Permit #ZP24-000047, ZP24-000048

Plan Revisions Narrative

This narrative explains plan revisions to the Design Review Application for 720 Broadway – ZP24-000047. Due to the costs associated with building a basement in the high-water table of the existing site, the basement level has been valued engineered out of the project. The building footprint and setbacks on Levels 1,2,3 & 4 remain the same as in the approved Design Review Application. As a result of the overall gross square footage of the building being reduced (due to removal of basement), the total number of residential units has been reduced from 28 to 25 total units, following “Density Factor” for Lot Area>5,000.

A-28

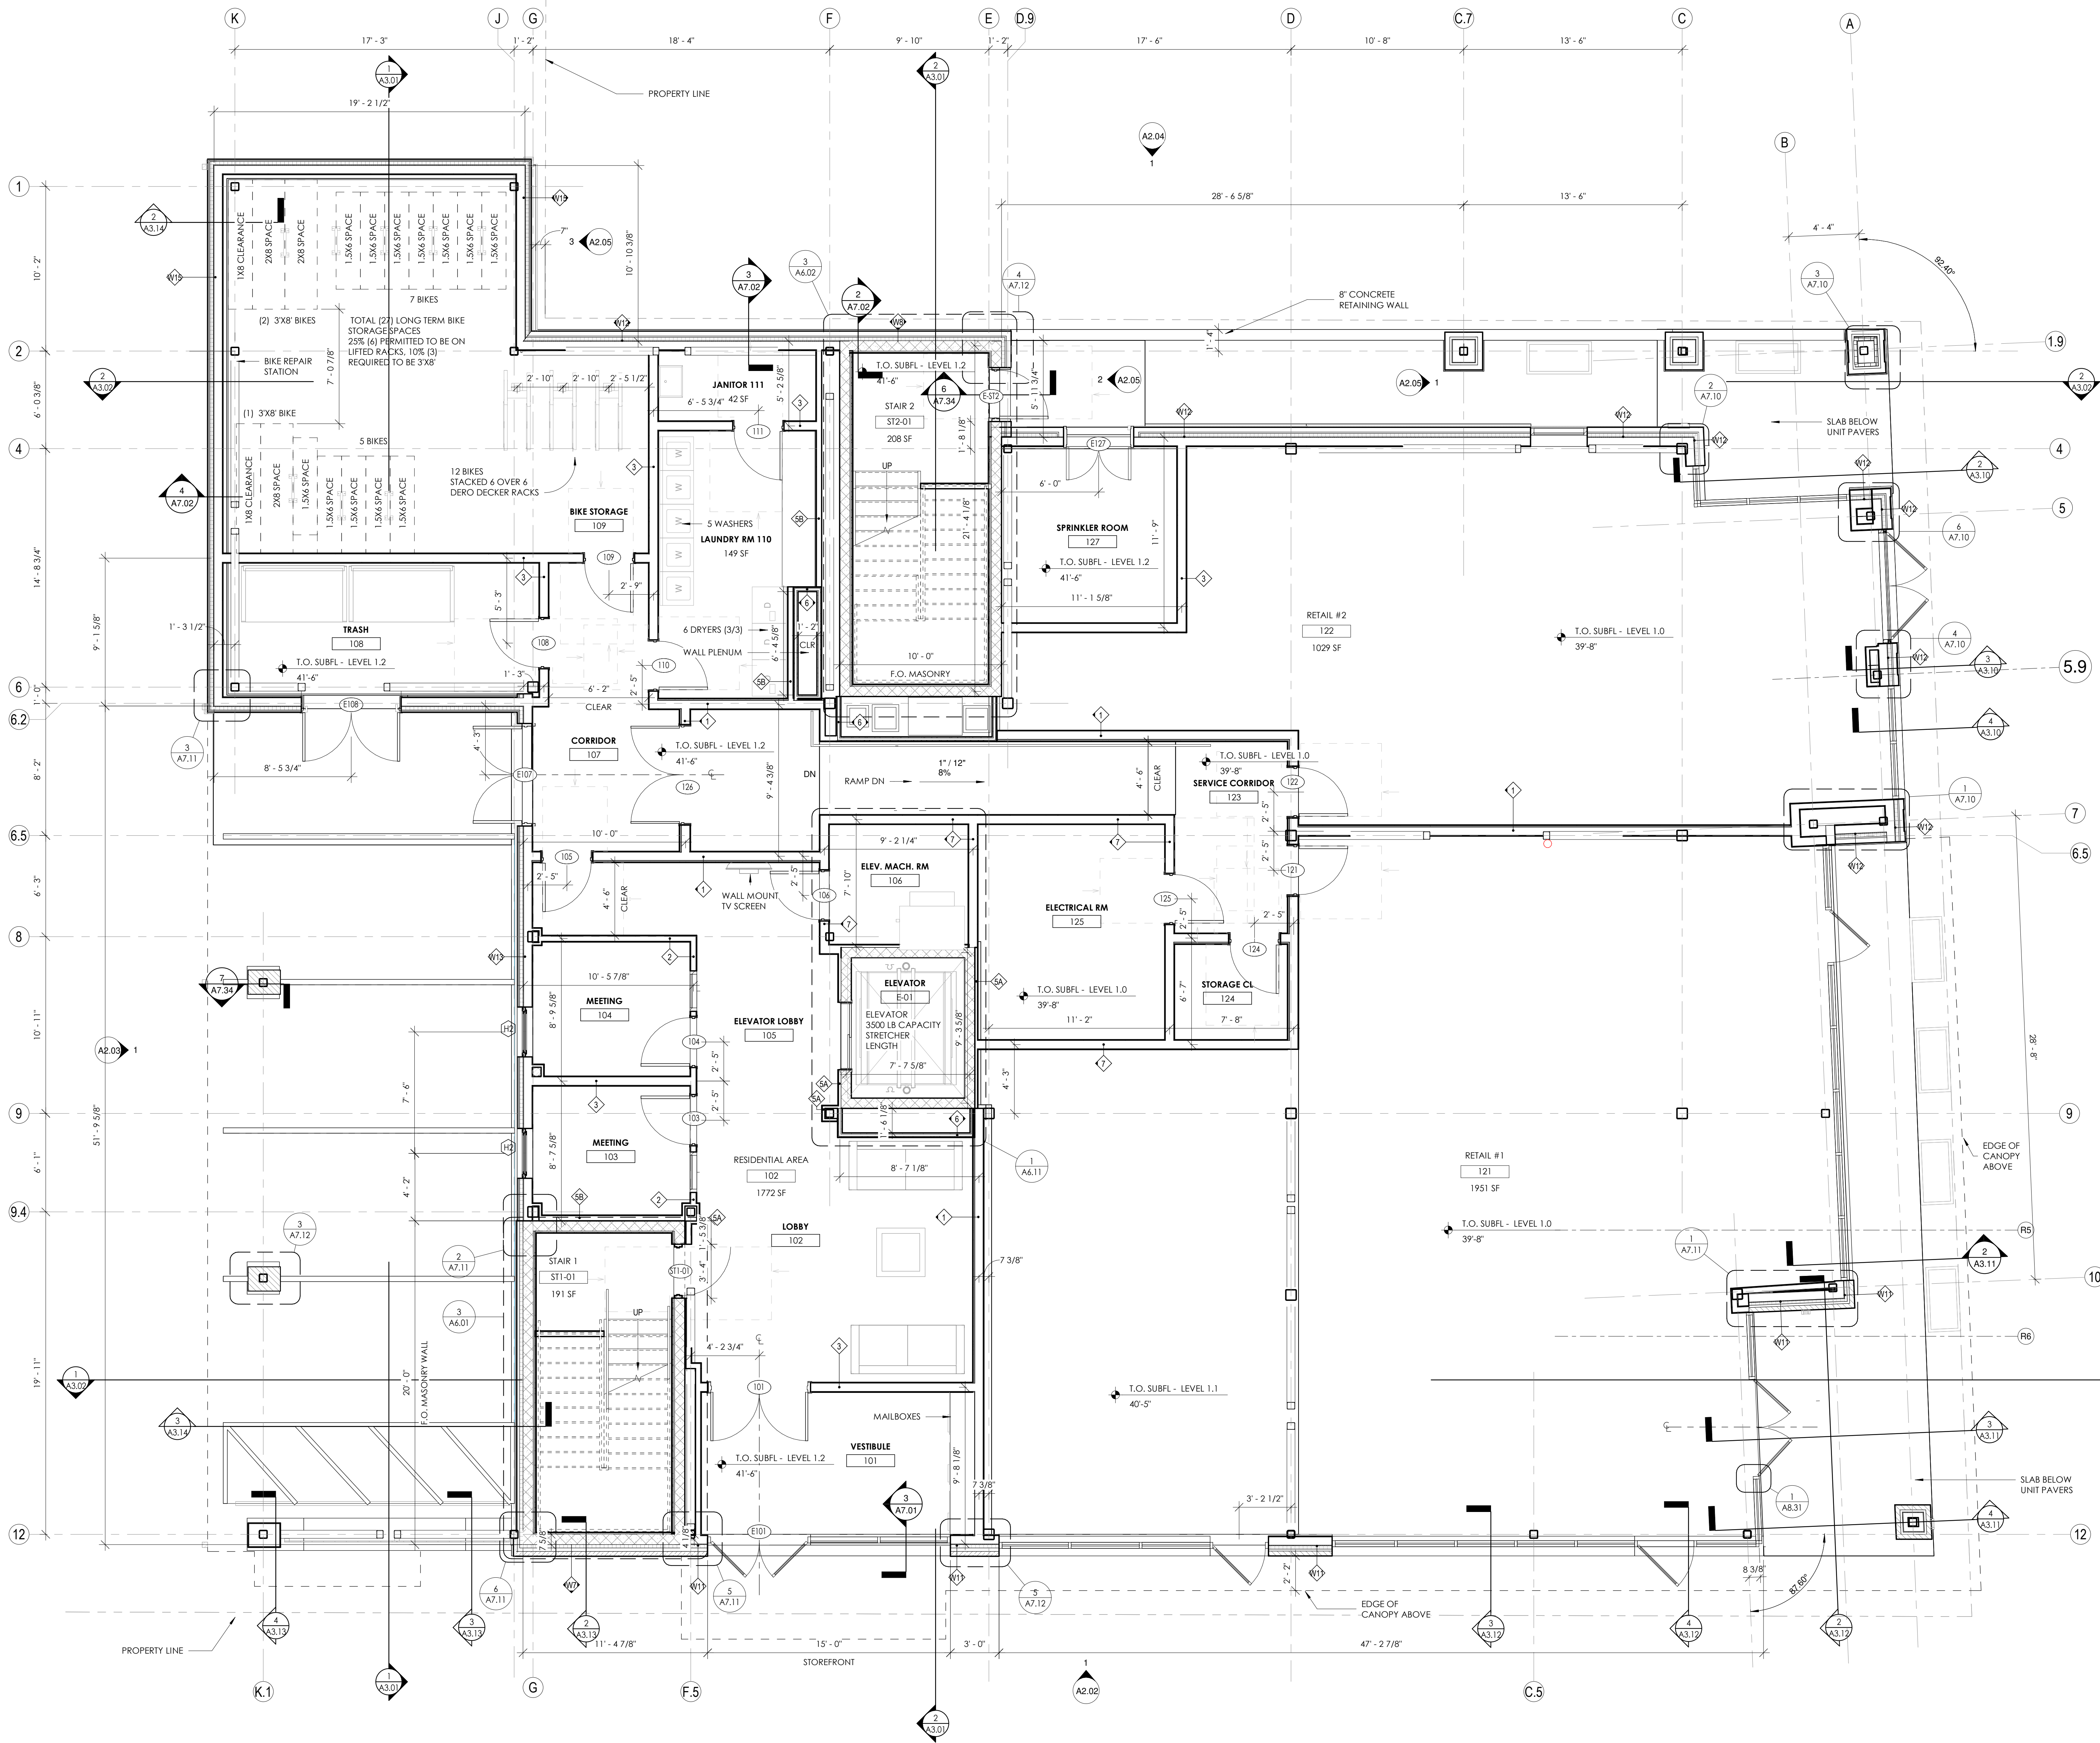
Revised fenestration calculations

2.4.5 USES AND FEATURES:
FENESTRATION IS MEASURED
BETWEEN 2 FT & 12 FT ABOVE
FINISHED FL

4.2.8.d USES AND FEATURES:
GROUND STORY FENESTRATION
SECONDARY FACADE MIN/MAX
15%/70%

UPPER STORY FENESTRATION
MIN/MAX 15%/50%

LEVEL 4 WALL AREA: 1,054 SF
LEVEL 4 FENESTRATION AREA: 231 SF
LEVEL 4 FENESTRATION PRECENTAGE: 22%

LEVEL 3 WALL AREA: 1119 SF
LEVEL 3 FENESTRATION AREA: 289 SF
LEVEL 3 FENESTRATION PRECENTAGE: 26%

LEVEL 2 WALL AREA: 1113 SF
LEVEL 2 FENESTRATION AREA: 275 SF
LEVEL 2 FENESTRATION PRECENTAGE: 25%

LEVEL 1 (SECONDARY FACADE) WALL AREA: 1,058 SF
LEVEL 1 FENESTRATION AREA: 500 SF
LEVEL 1 FENESTRATION PRECENTAGE: 47%
(MEASURED BETWEEN 2' & 12' AFF)

2.4.5 USES AND FEATURES:
FENESTRATION IS MEASURED
BETWEEN 2 FT & 12 FT ABOVE
FINISHED FL

4.2.8.d USES AND FEATURES:
GROUND STORY FENESTRATION
PRIMARY FACADE MIN 70%

UPPER STORY FENESTRATION
MIN/MAX 15%/50%

LEVEL 4 WALL AREA: 1,011 SF
LEVEL 4 FENESTRATION AREA: 290 SF
LEVEL 4 FENESTRATION PRECENTAGE: 27%

LEVEL 3 WALL AREA: 796 SF
LEVEL 3 FENESTRATION AREA: 290 SF
LEVEL 3 FENESTRATION PRECENTAGE: 36%

LEVEL 2 WALL AREA: 796 SF
LEVEL 2 FENESTRATION AREA: 290 SF
LEVEL 2 FENESTRATION PRECENTAGE: 36%

LEVEL 1 (PRIMARY FACADE) WALL AREA: 755 SF
LEVEL 1 FENESTRATION AREA: 557 SF
LEVEL 1 FENESTRATION PRECENTAGE: 74%
(MEASURED BETWEEN 2' & 12' AFF)
